NHTSA Safety Recall 14V-506

SUBJECT: Campaign #131 – Roof Air Conditioner Damper Plate

INSTRUCTIONS TO PERFORM CAMPAIGN 131

Figure (A) indicates diverter above cooktop that will be replaced with damper plate

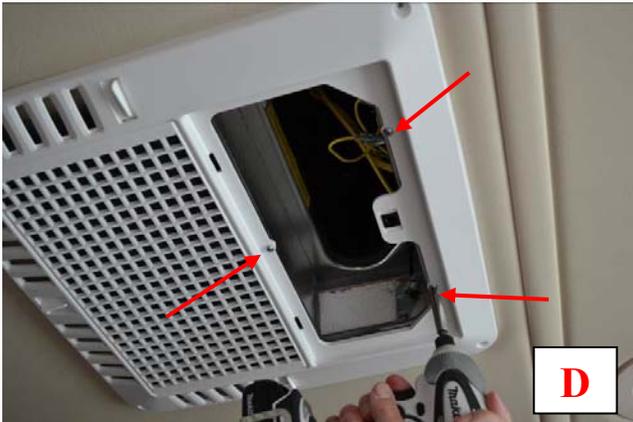
1. Remove (4) screws from perimeter of inside roof A/C assembly, (set aside). See *figure A and B*.

5. Using caution not to damage retaining tabs, install damper plate in place of diverter (label side up). See *figure G*.
